ADDENDUM

Project Name:	UNK University Village Student Housing
Project Number:	15097
Owner:	University of Nebraska at Kearney
Addendum Number:	01, Revision 01
Date:	April 21, 2016
By:	Matt Neaderhiser, Holland Basham Architects
To:	Project Bidders

This Addendum to the project bidding documents and attached reference drawings dated April 21, 2016, issued to inform bidders of revisions to the bidding documents.

01 Overall Landscape Plan

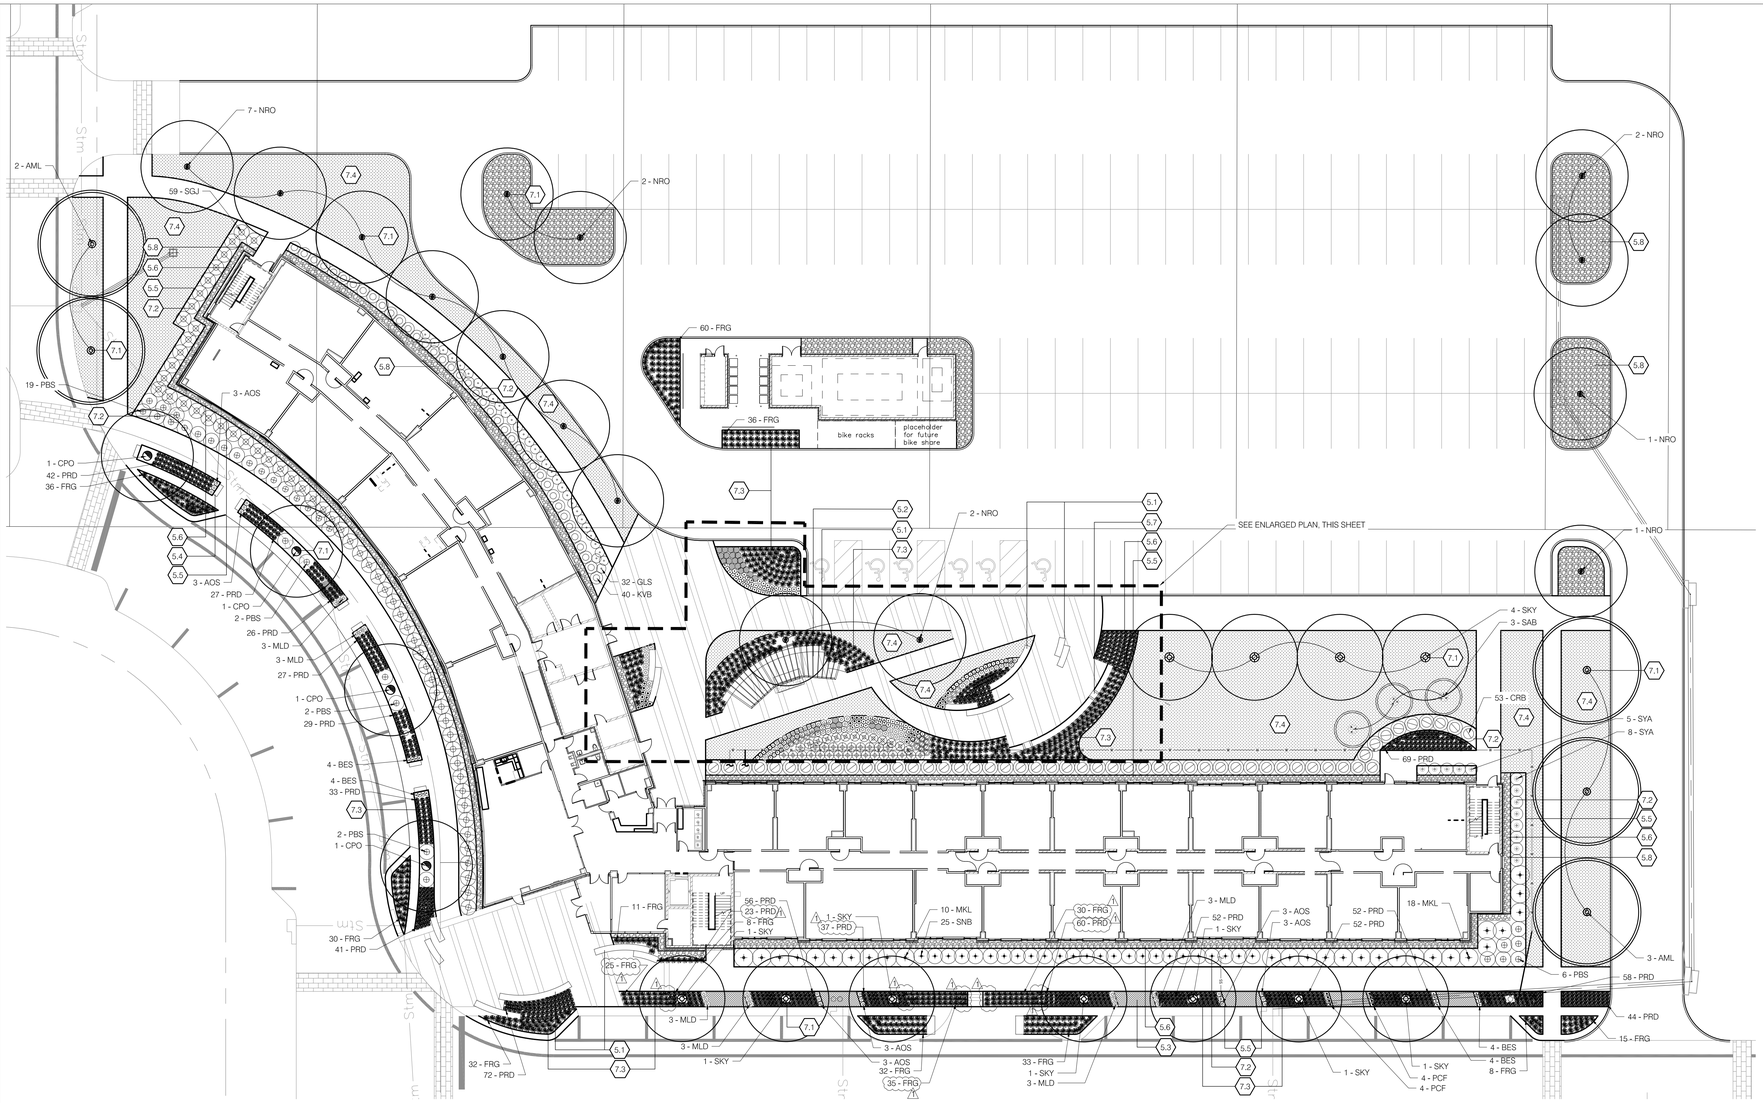
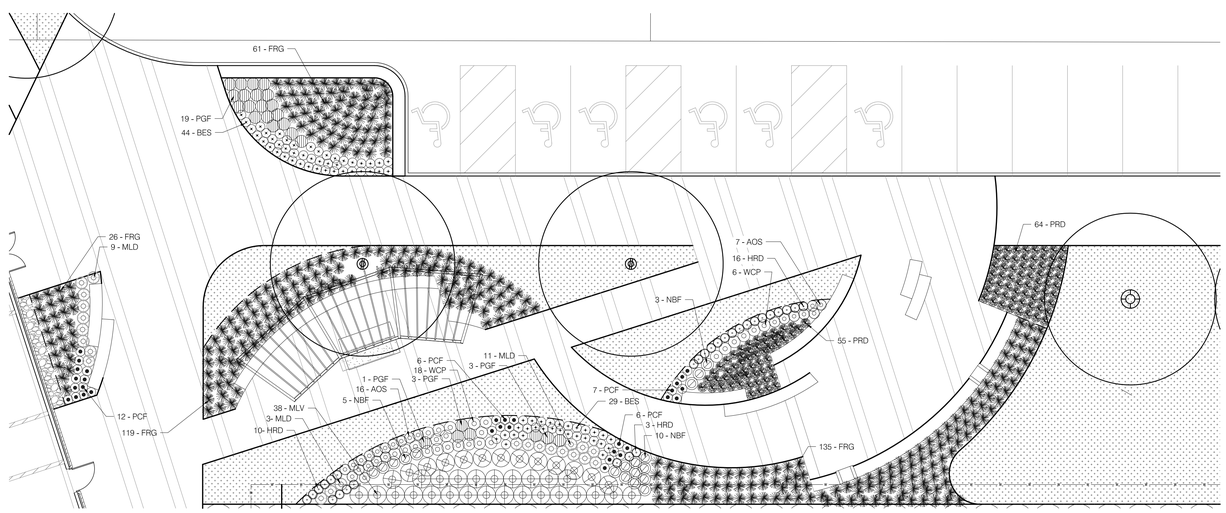
1-1 Sheet L1.00 – 02/Plant Schedule – CHANGE quantities of 'Feather Reed Grass'/FRG to 732
1-2 Sheet L1.00 – 02/Plant Schedule – CHANGE quantities of 'Prairie Dropseed'/PRD to 921
1-3 Sheet L1.00 – 01/Overall Landscape Plan – ADD 6 Prairie Dropseed and 21 Feather Reed Grass to fill in areas where seat walls were removed along streetscape (RE:Civil)
1-4 Sheet L2.00 – Detail 01/Mow Strip – CHANGE Steel Edging to Aluminum Edging per specifications.
1-5 Sheet L2.00 – Detail 06/Flagstone Walkthrough Detail – CHANGE Joint material from grout to decomposed granite.

2 A0.12 THIRD FLOOR CODE REVIEW PLAN
0' 4' 8' 16' 32'

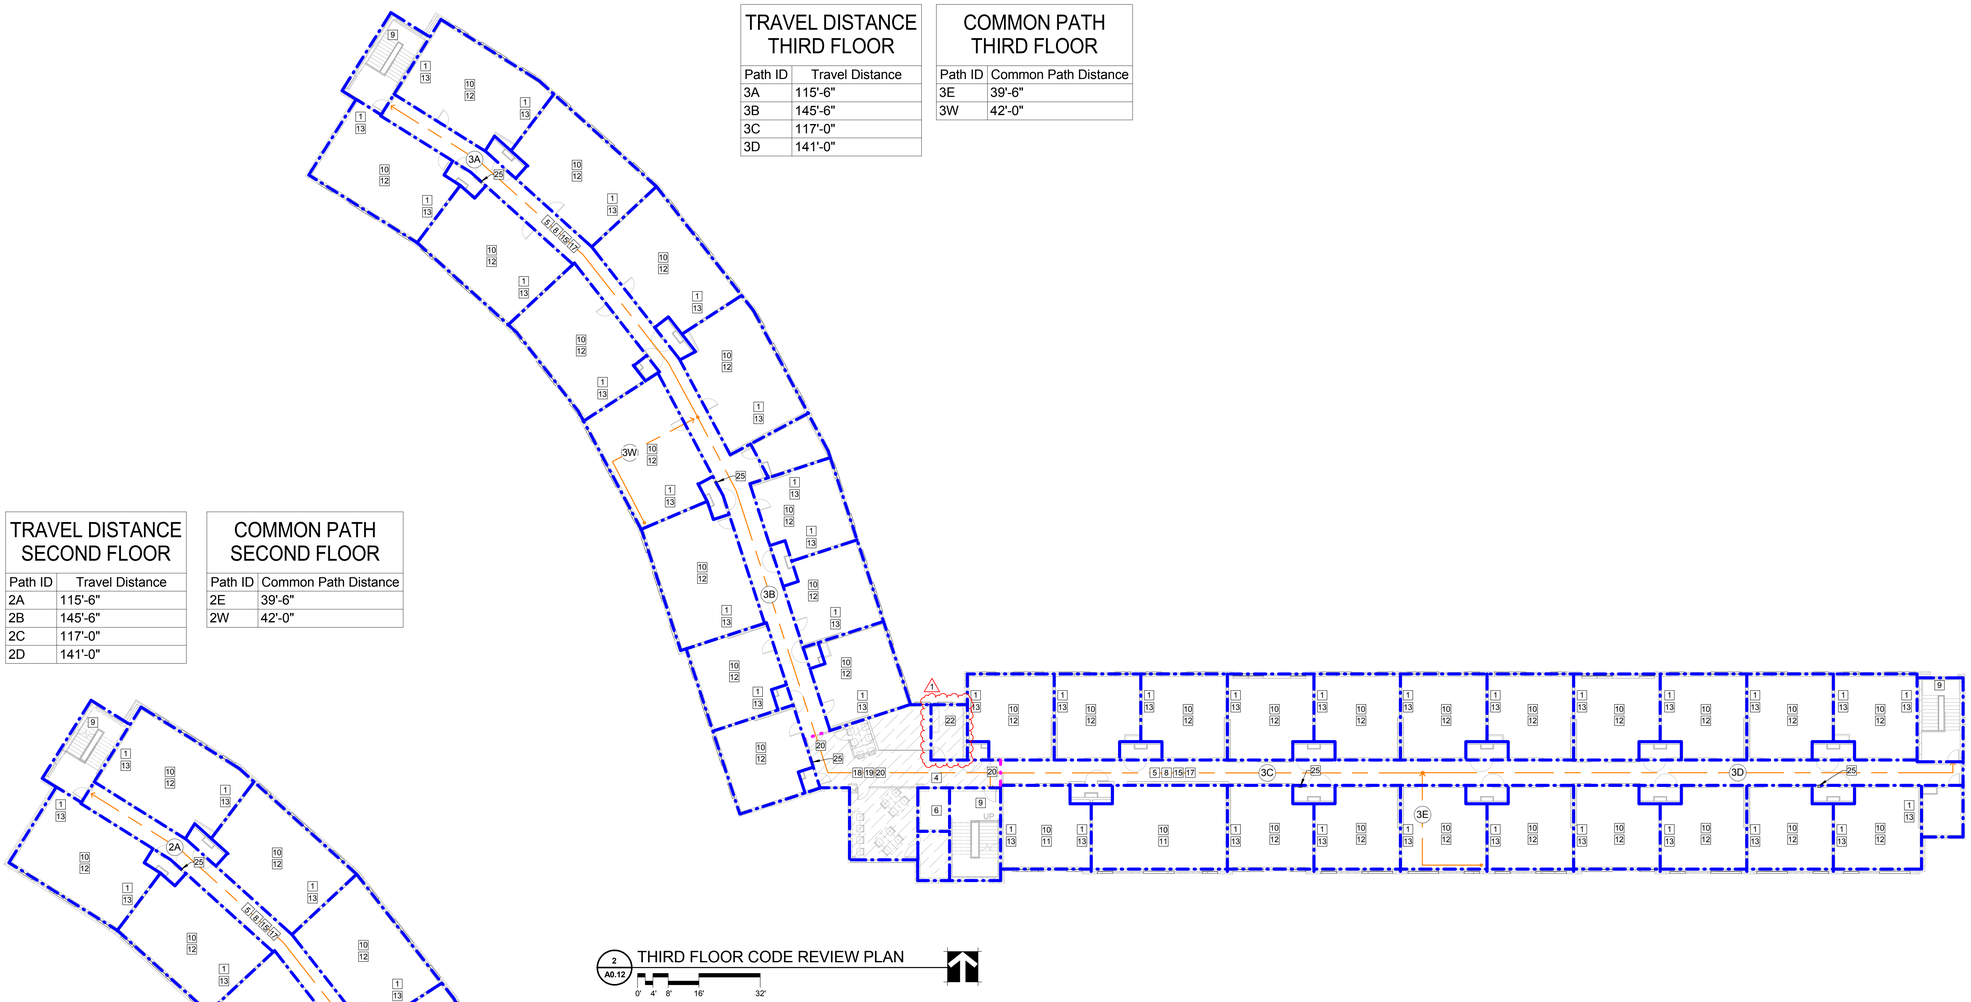
SHEET A0.12 – CODE REVIEW PLANS
1. This sheet is REVISED and REISSUED with this revision.
2. Add 1-HR rating around Laundry Room at 2nd and 3rd floor.

1 A0.41 FIRST FLOOR PLAN

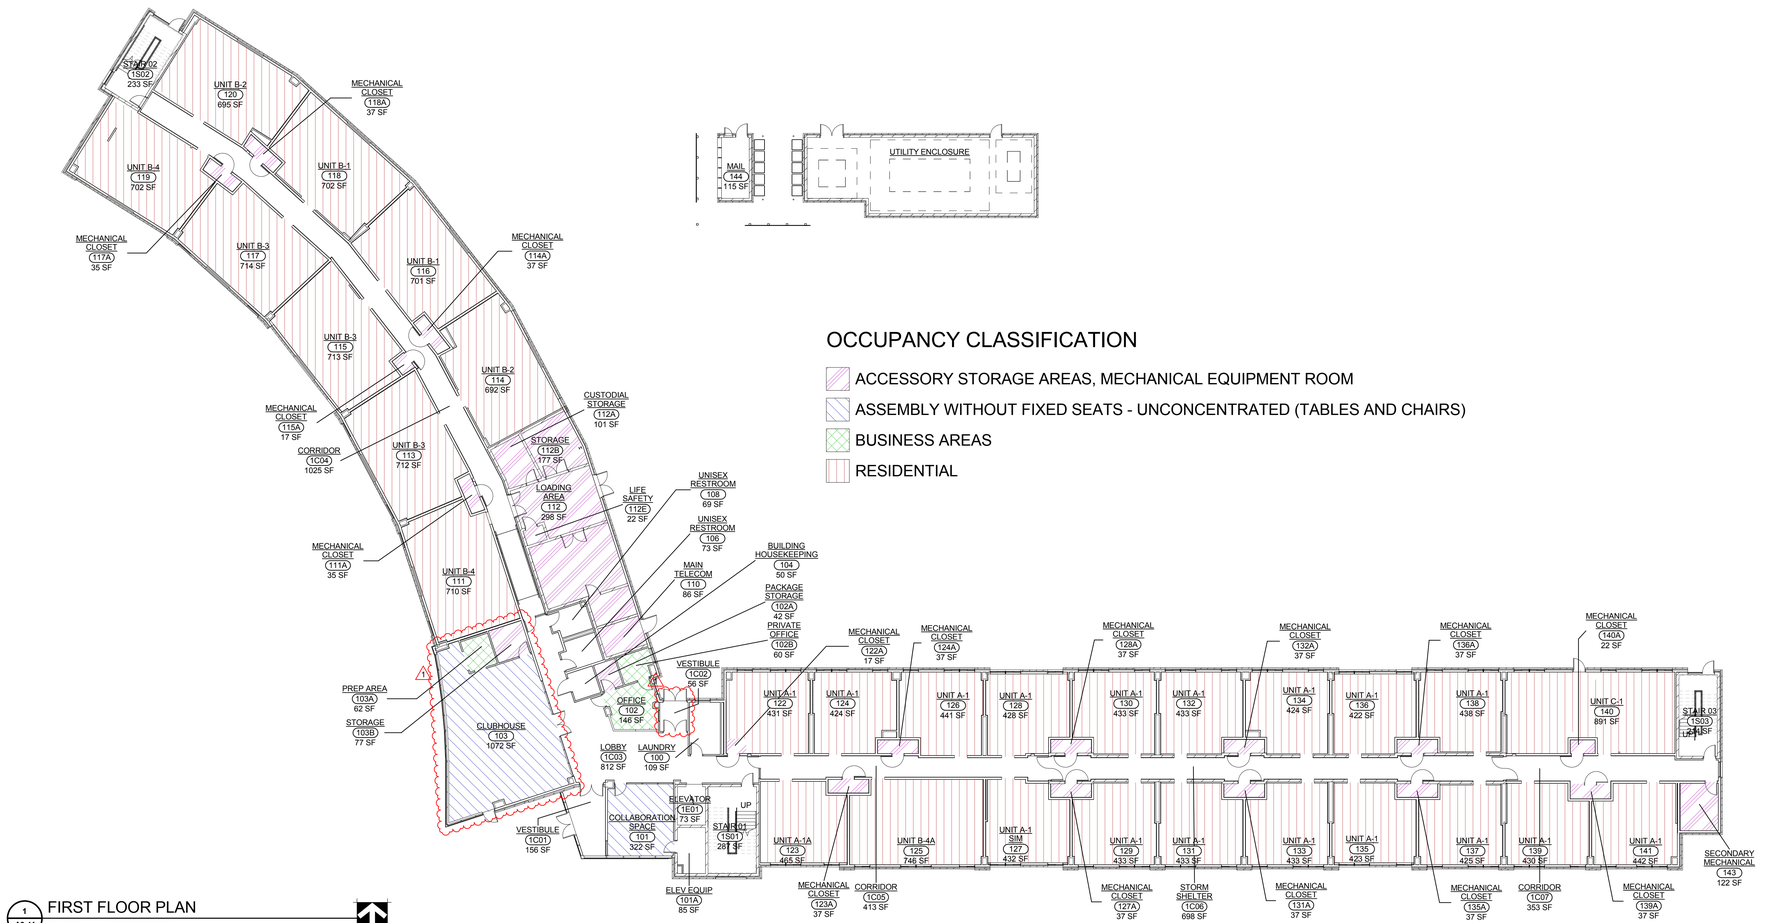
SHEET A0.41 – OCCUPANCY REVIEW PLANS
1. This sheet is REVISED and REISSUED with this revision.
2. Update clubhouse and storage occupancy.

1 A1.01B FIRST FLOOR PLAN - EAST WING

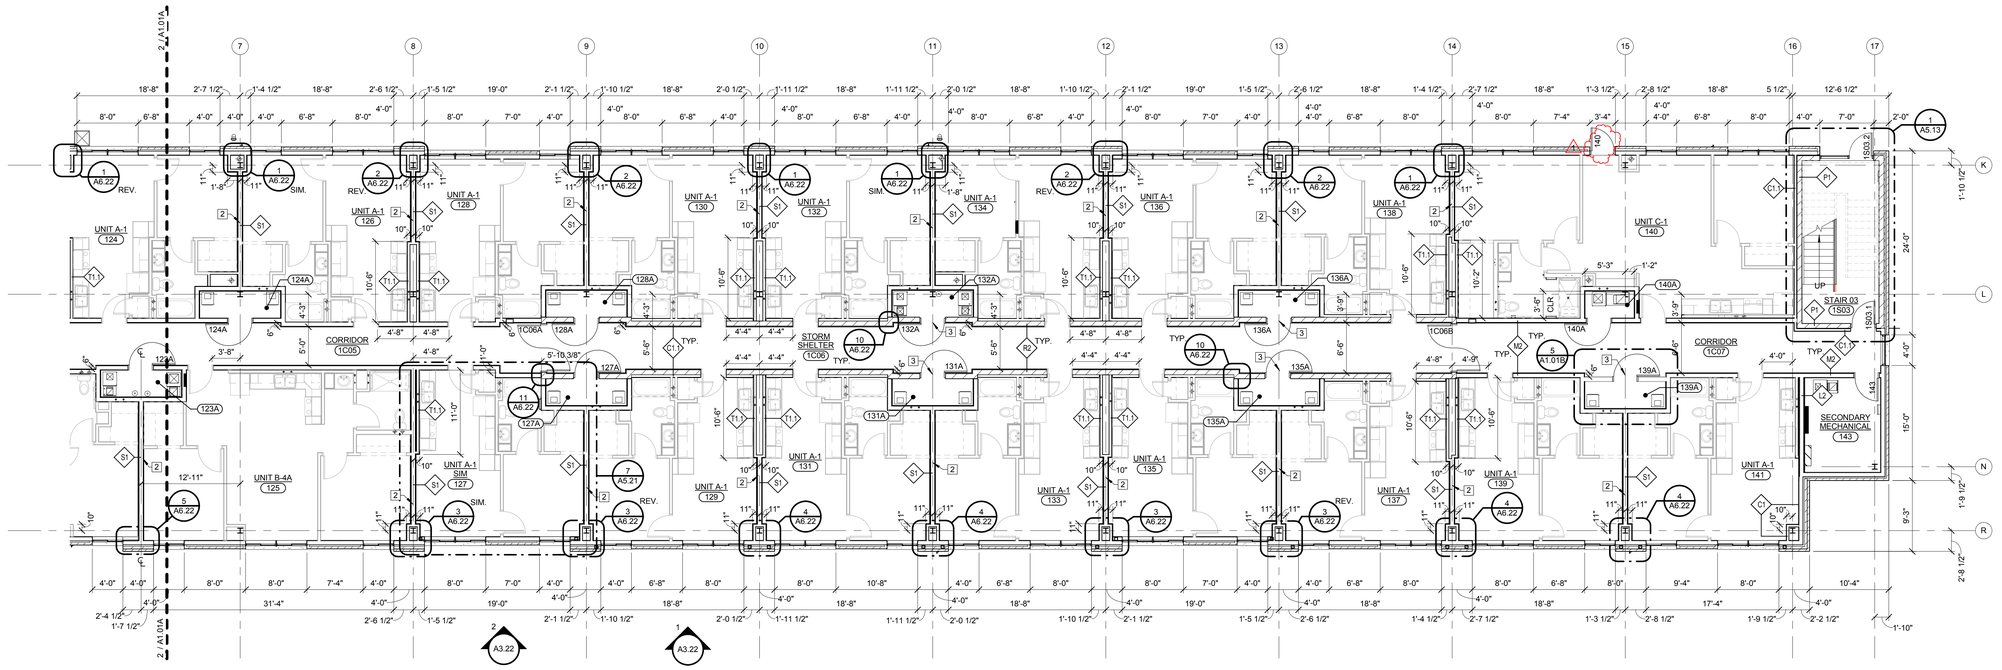
SHEET A1.01B – FIRST FLOOR PLAN – EAST WING & ENCLOSURE
1. This sheet is REVISED and REISSUED with this revision.
2. Unit C-1, Rm 140, exterior entry door changed from being Door C-1.03 on A5.24 Enlarged Unit Plan Door Schedule to being Door 140 on A2.11 Building Door Schedule.

1 SECOND FLOOR PLAN - WEST WING
A1.02A
0' 2' 4' 8' 16'

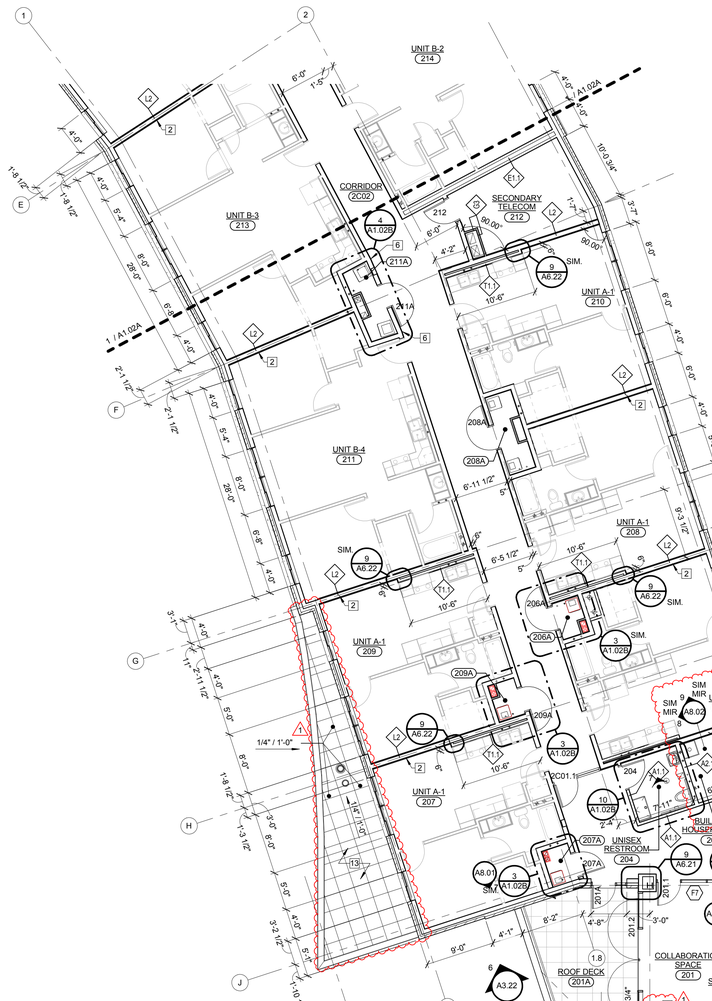
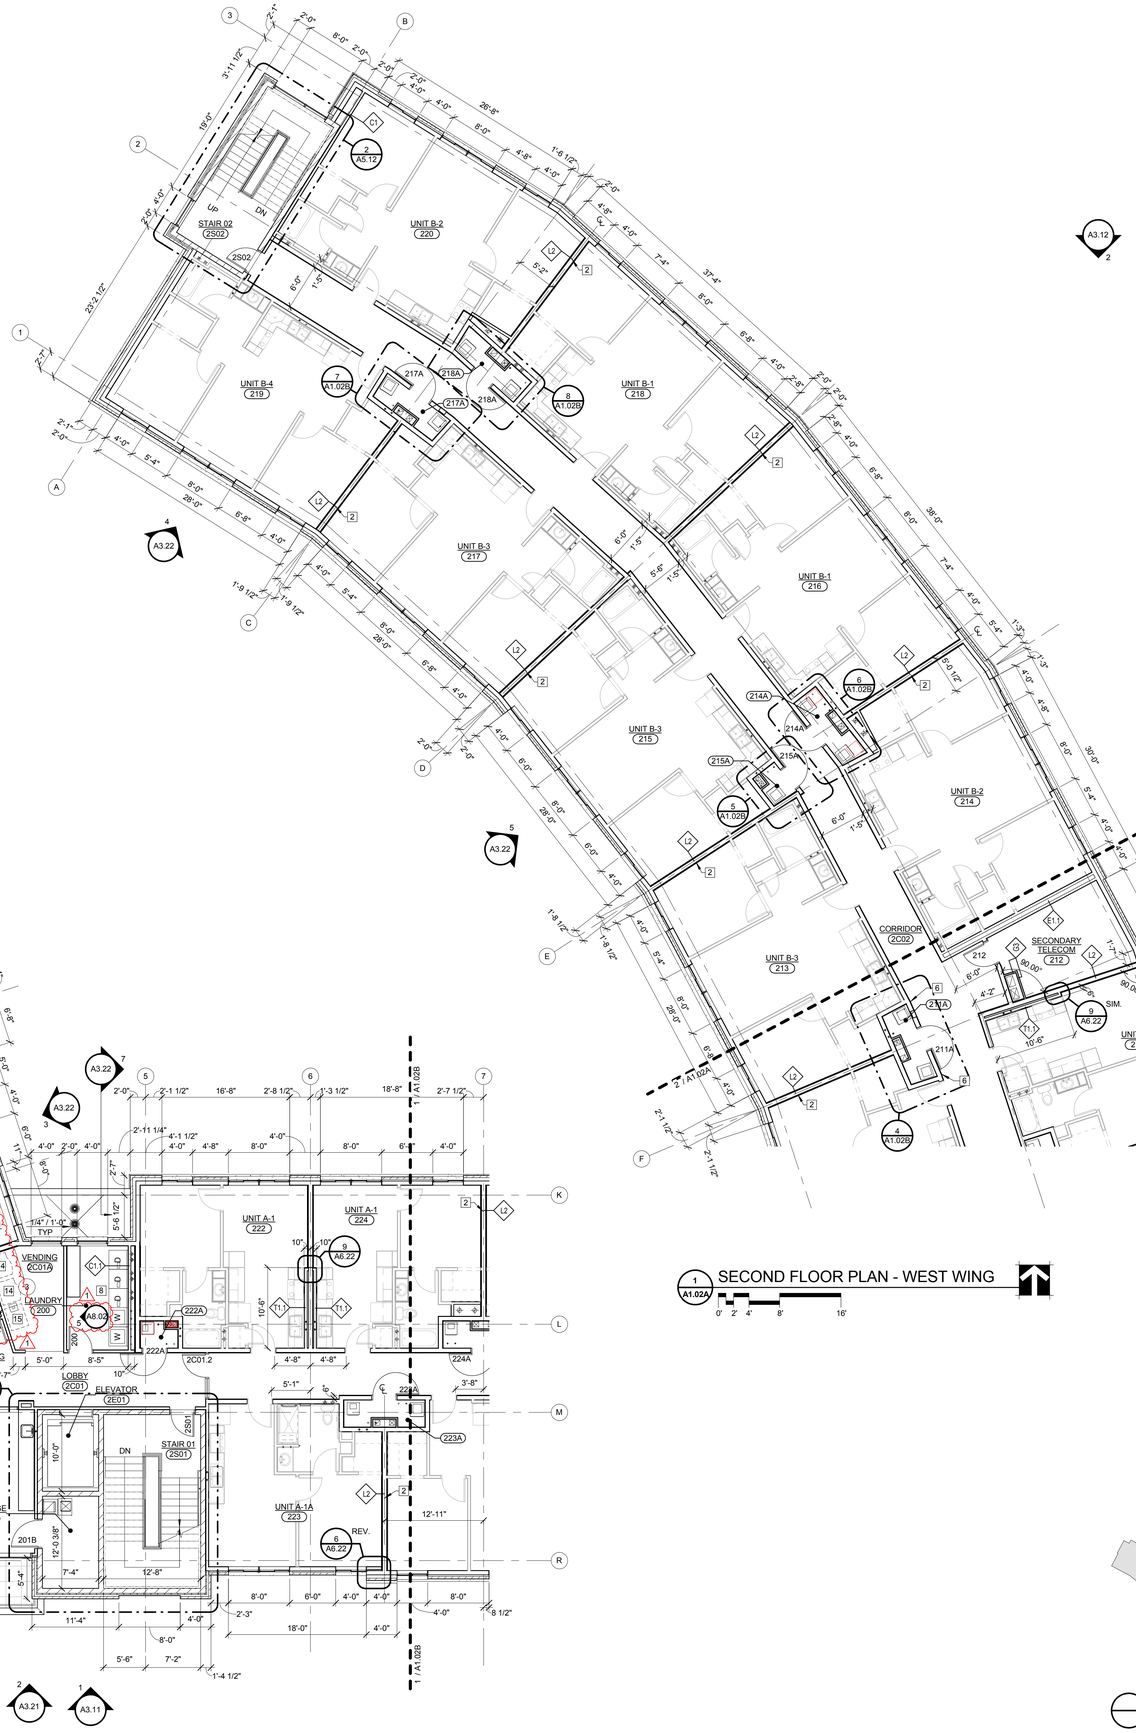
SHEET A1.02A – SECOND FLOOR PLAN – WEST WING & CENTER
1. This sheet is REVISED and REISSUED with this revision.
2. Add elevation tag to Laundry 200.
